TCS BSC 3 LAYOUT
(AS BUILT)

TCS BSC 3 LAYOUT, WITH TMDS

TCS BSC 1 LAYOUT
(AS BUILT)

TCS BSC 1 LAYOUT, WIT TMDS

DETAIL C
SCALE 1 : 4

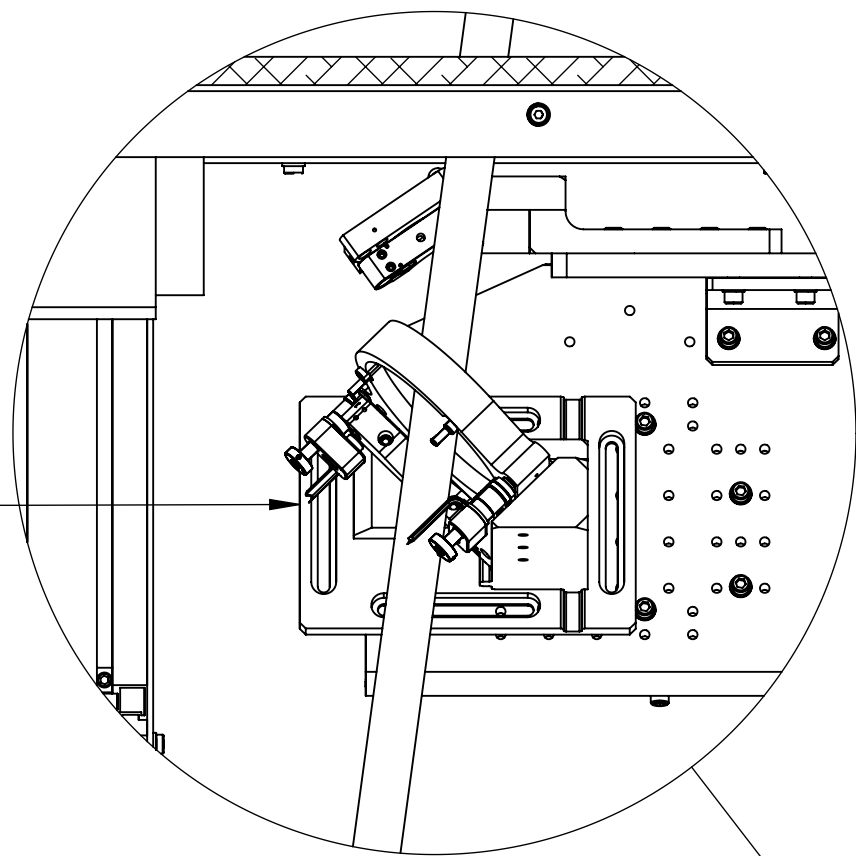
NEED
UPPER PERISCOPE
INTERFACE PLATE
TO ACCOMMODATE
HEIGHT REQUIREMENT
(NEW)

FRONT VIEW
ELEVATION 0° SIDE
(PARTIAL VIEW)

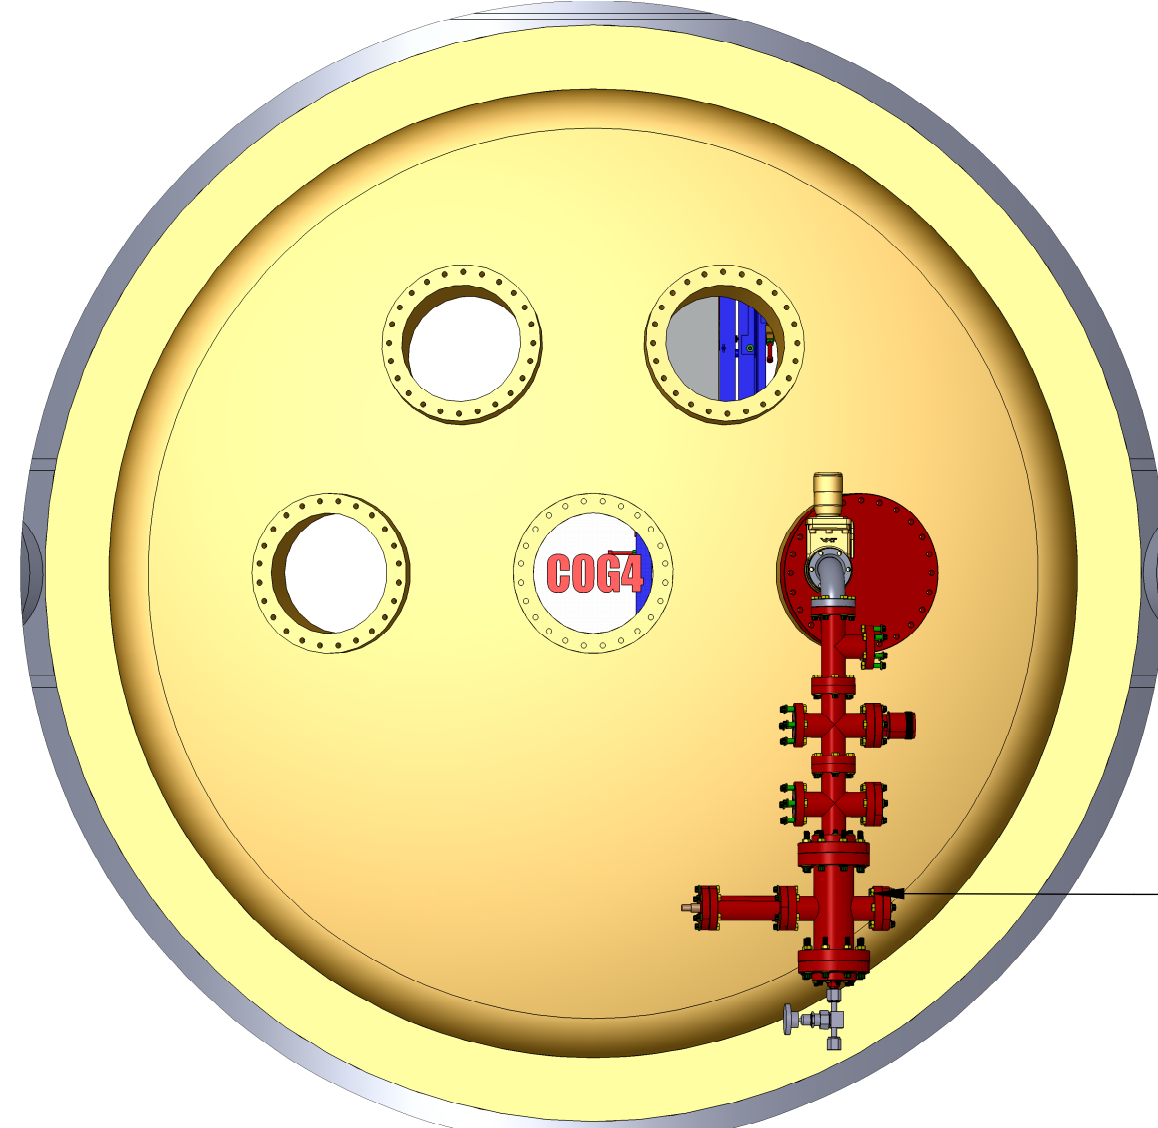
TMDS PROPOSED PORT
C0G5

SECTION B-B
SCALE 1 : 12

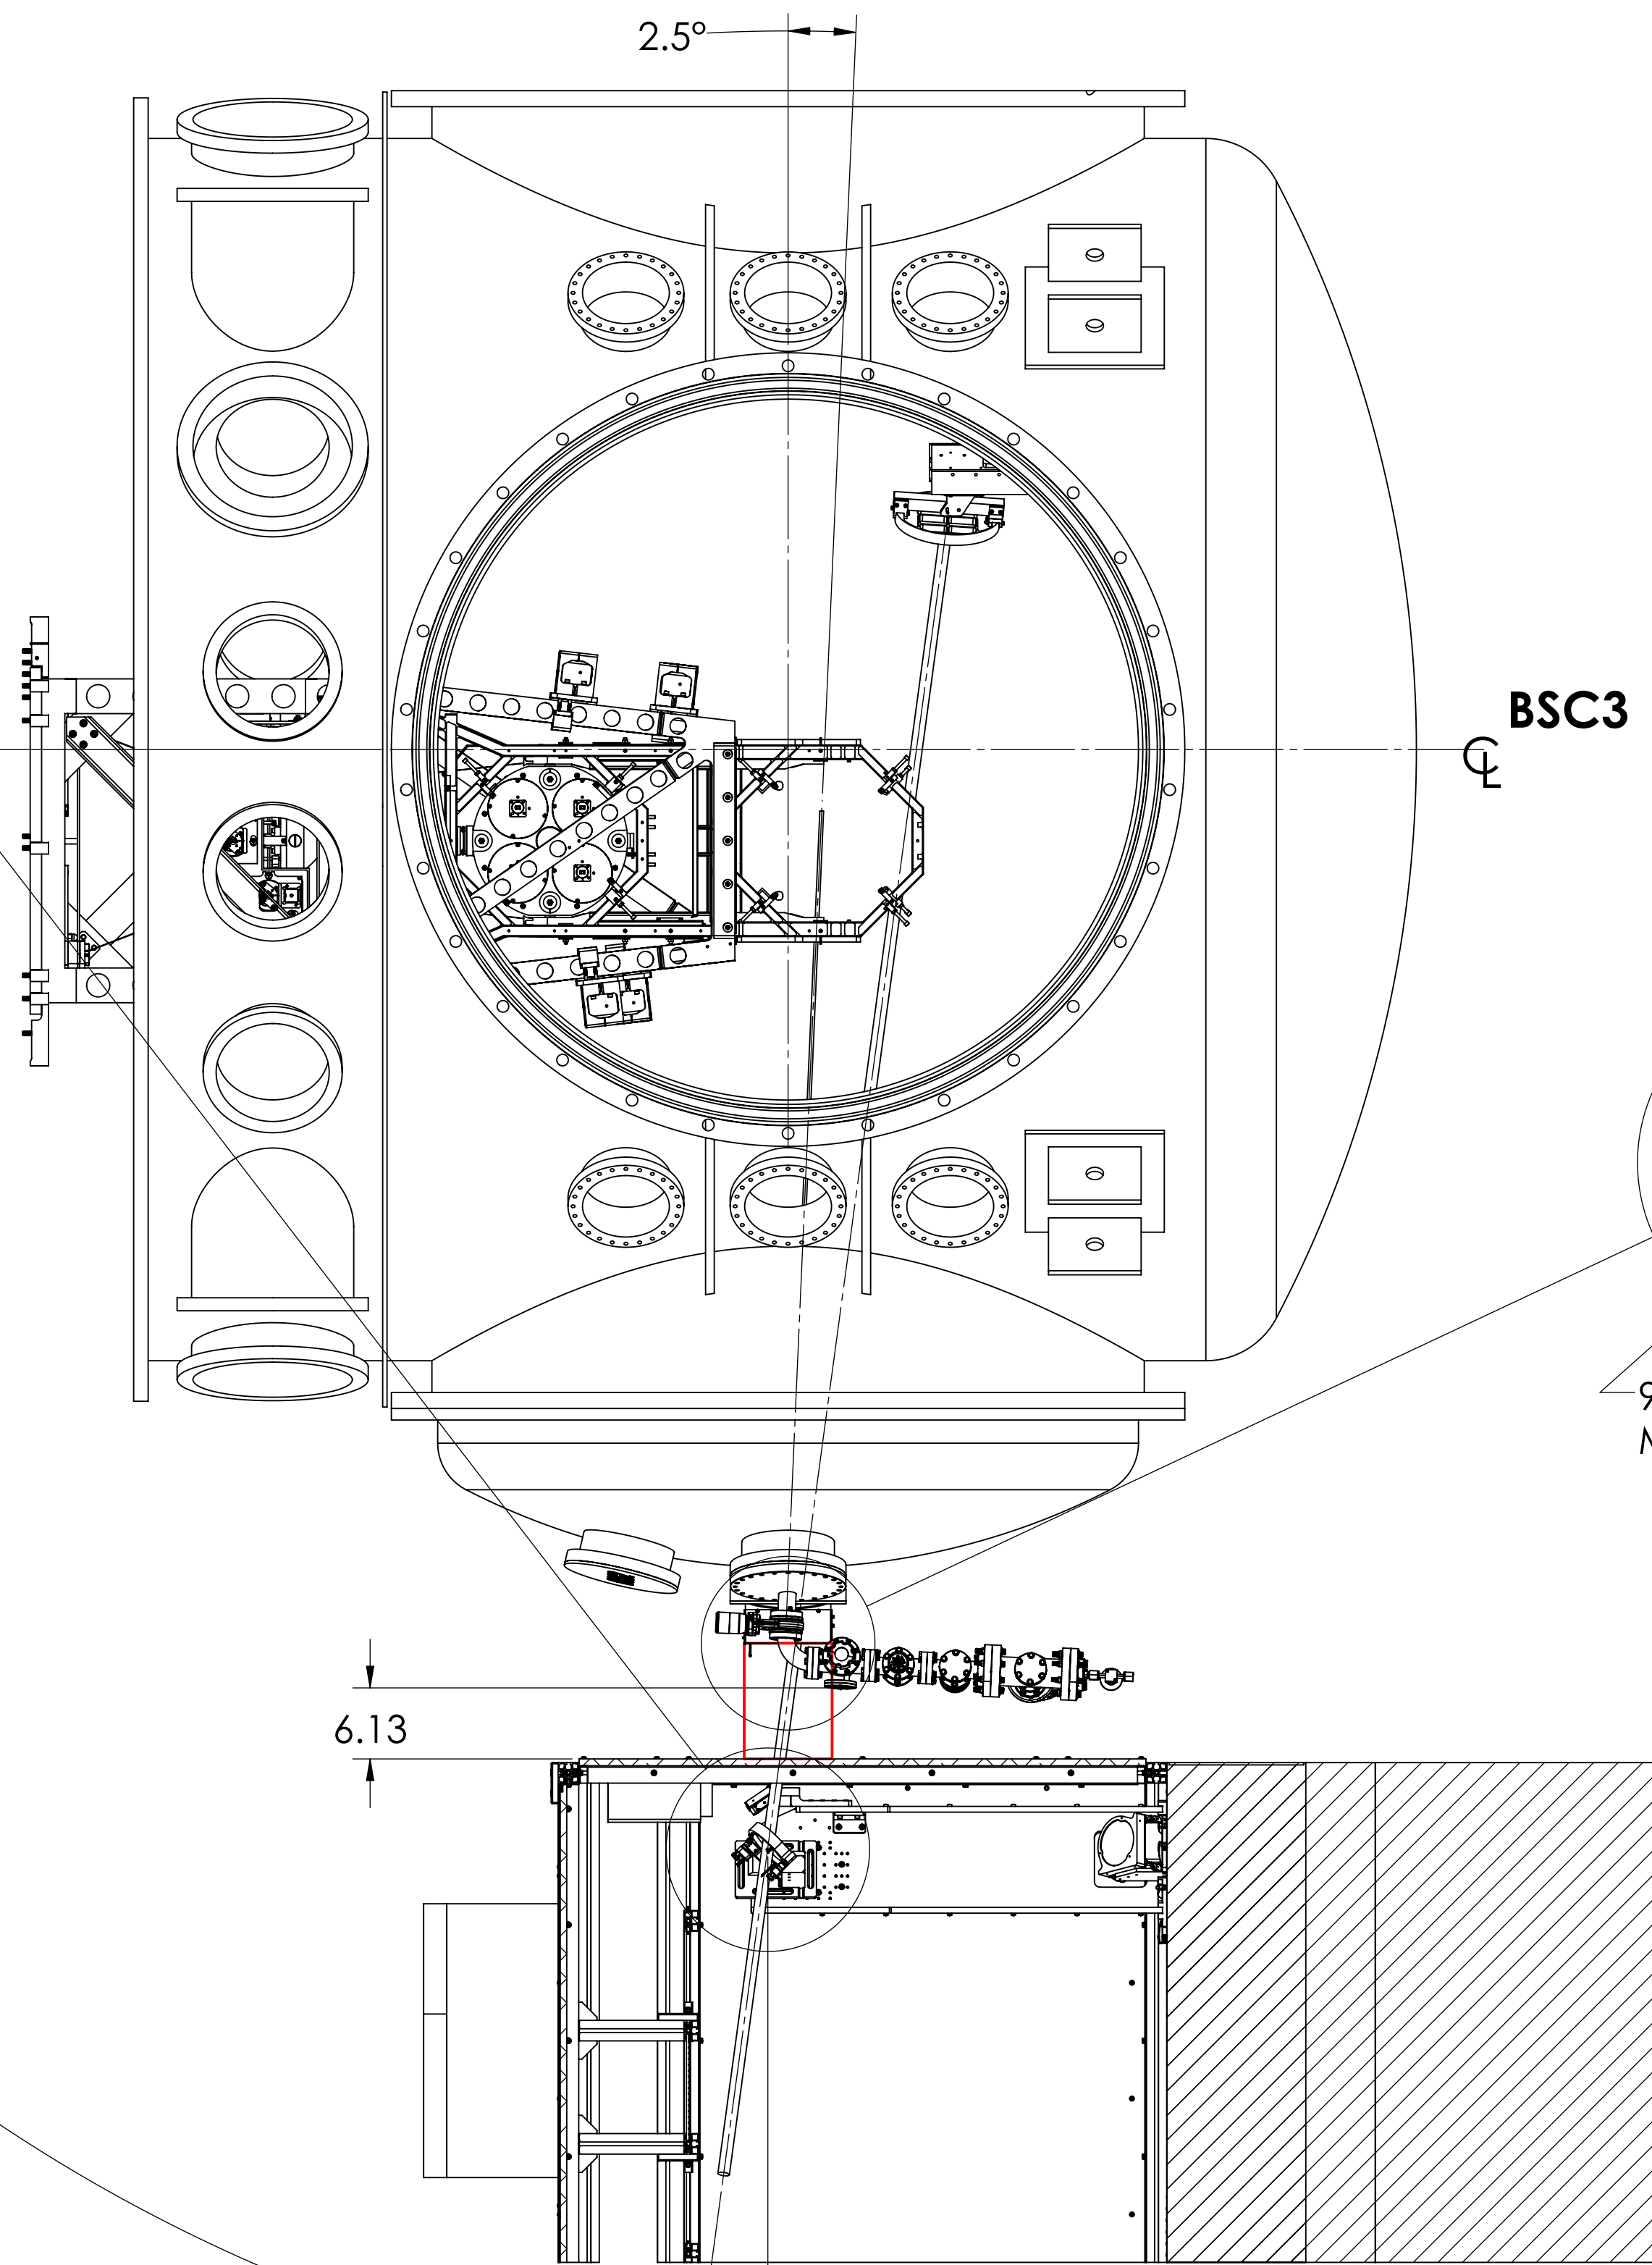
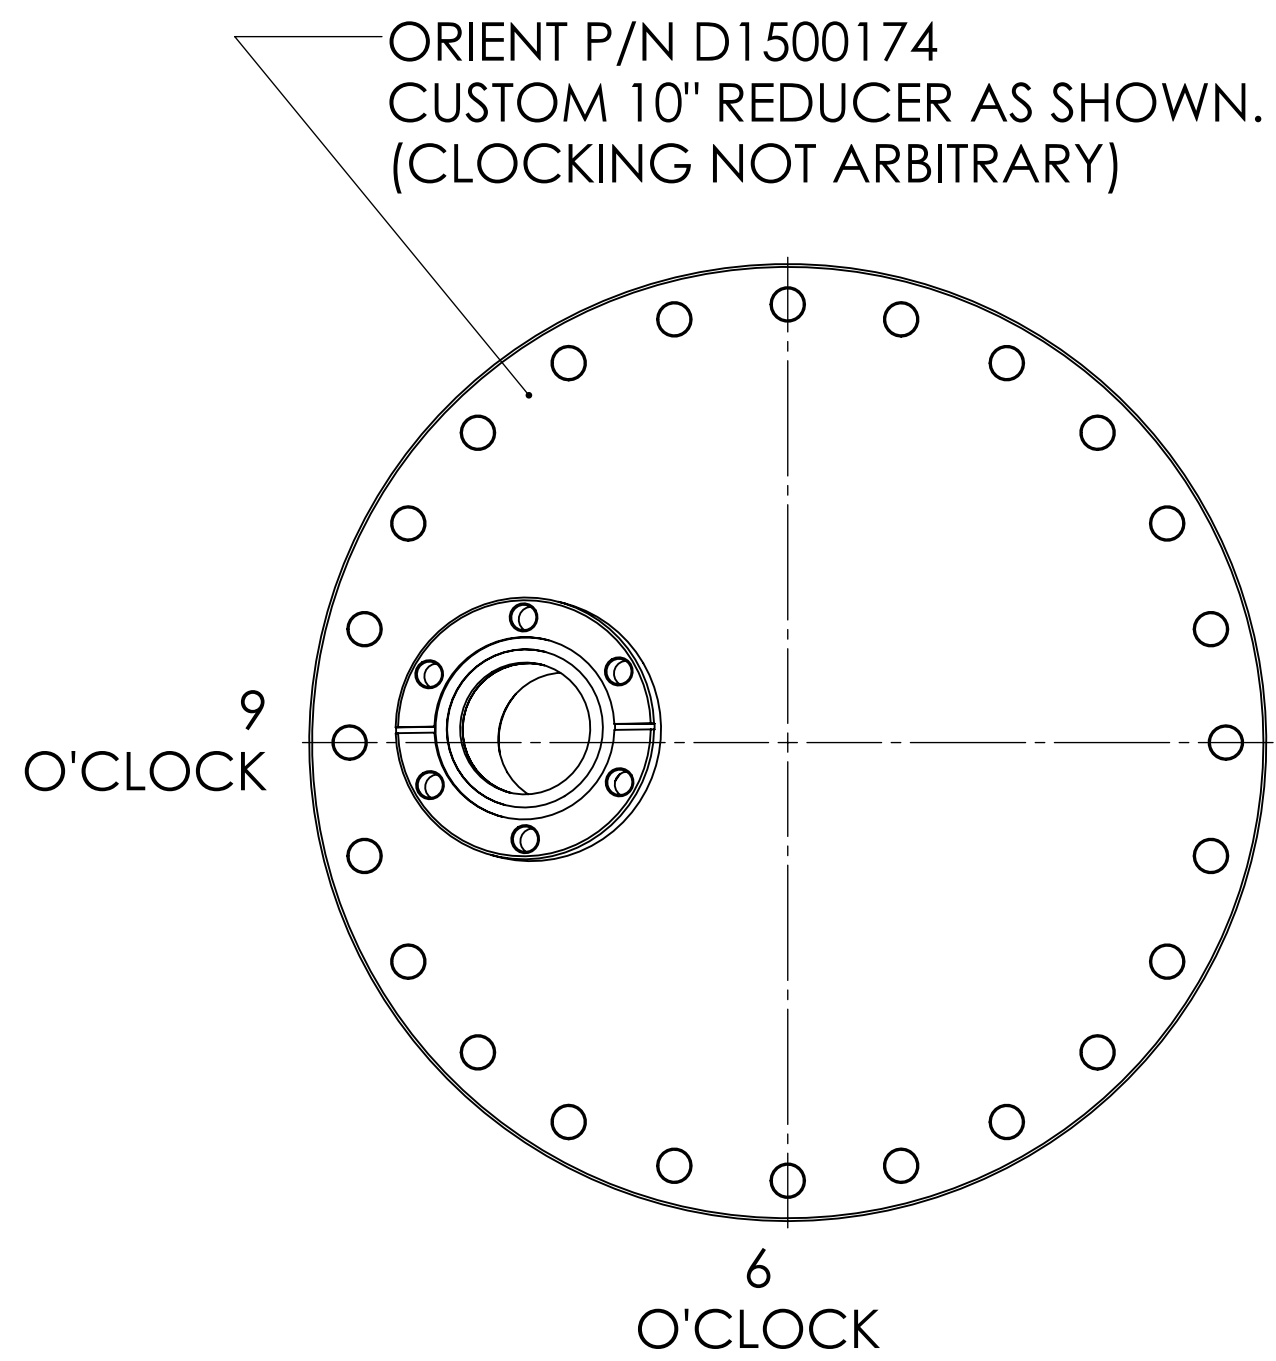
TMDS AND GATE VALVE, MAY BE Clocked TO SUIT
POTENTIAL LOCAL INTERFERENCES, ACCESS AND PREFERENCES.

SECTION G-G
SCALE 1:12
(ROTATED 180 DEGREES CW)

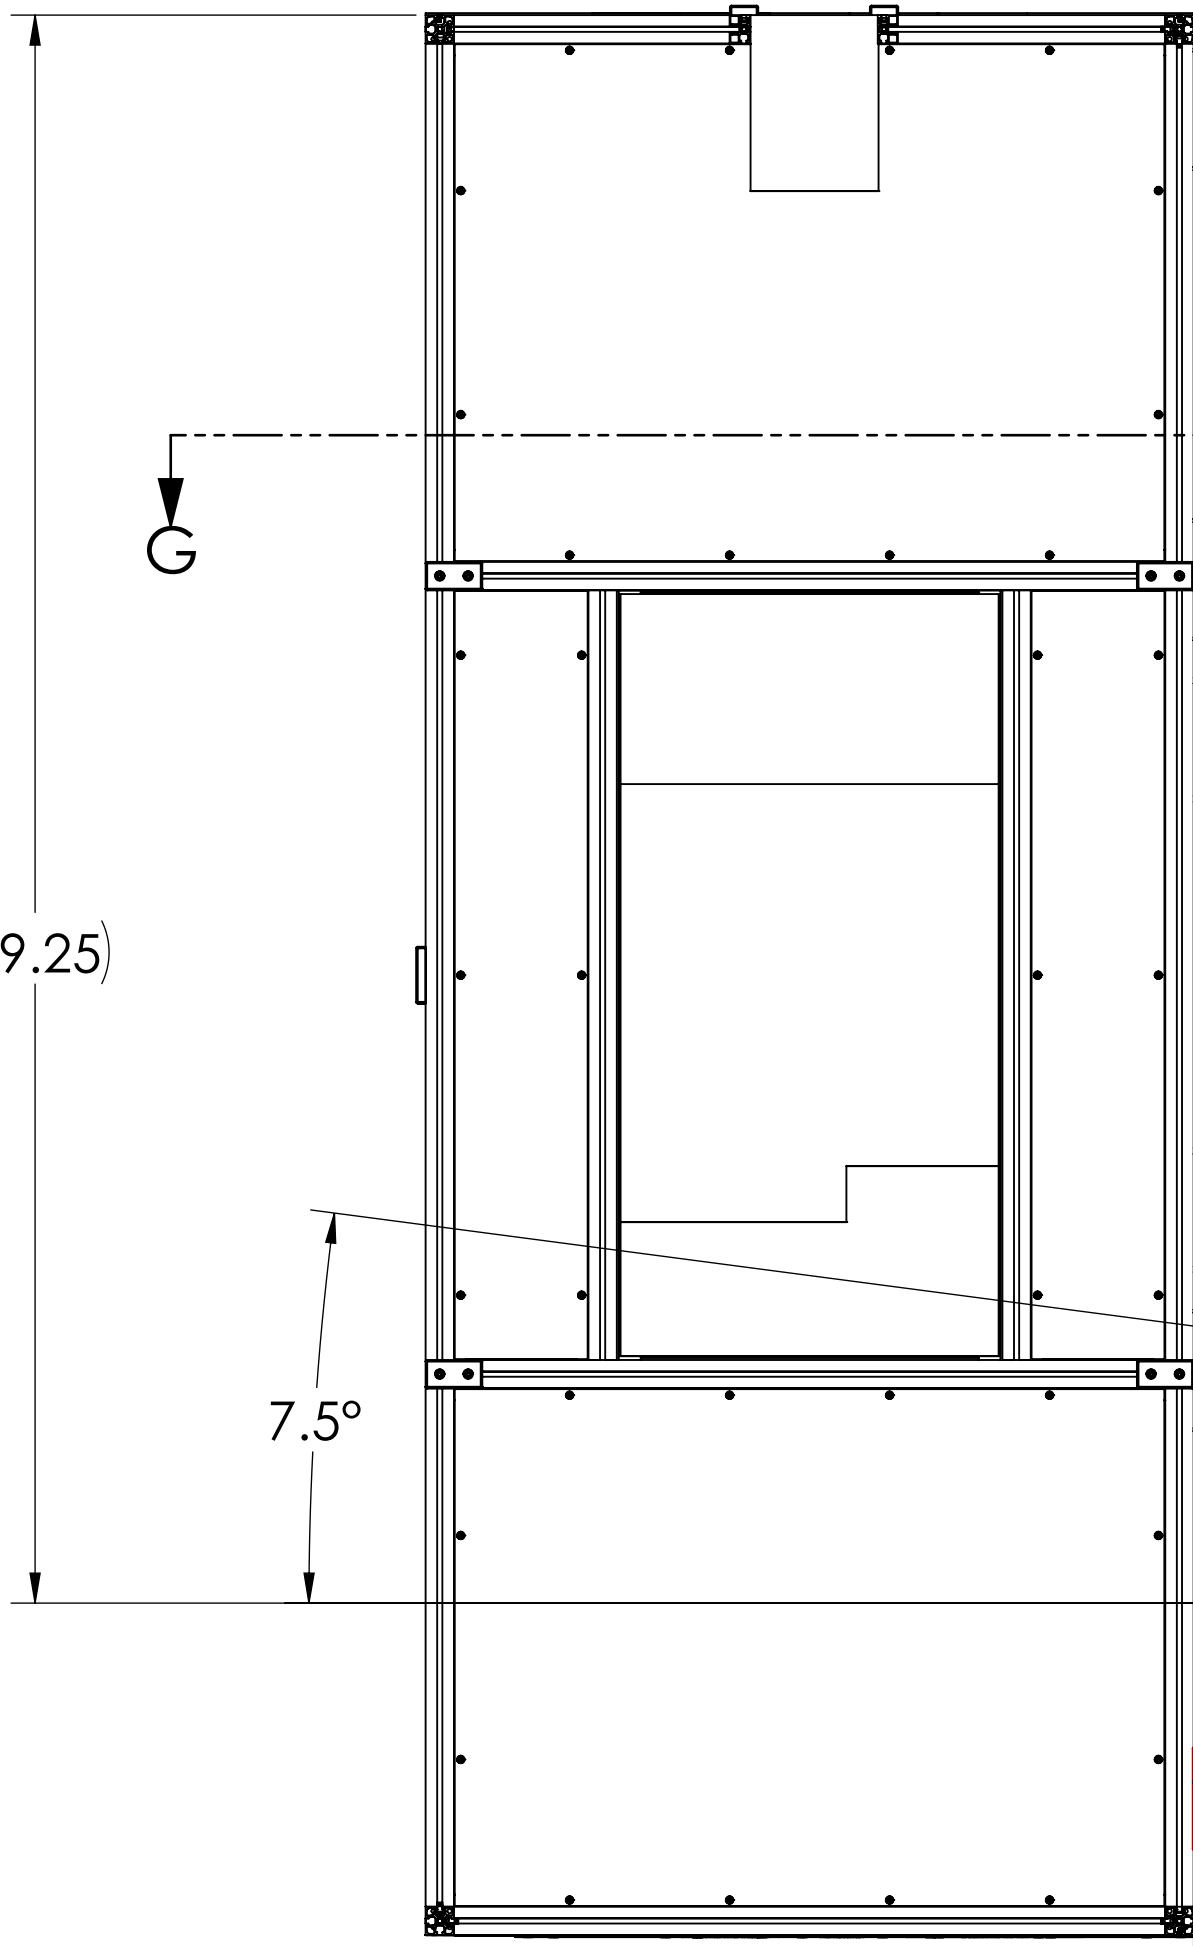
NEW BEAM
PIPE

MOVE 11.5 IN.

MOVE 3.25 IN.
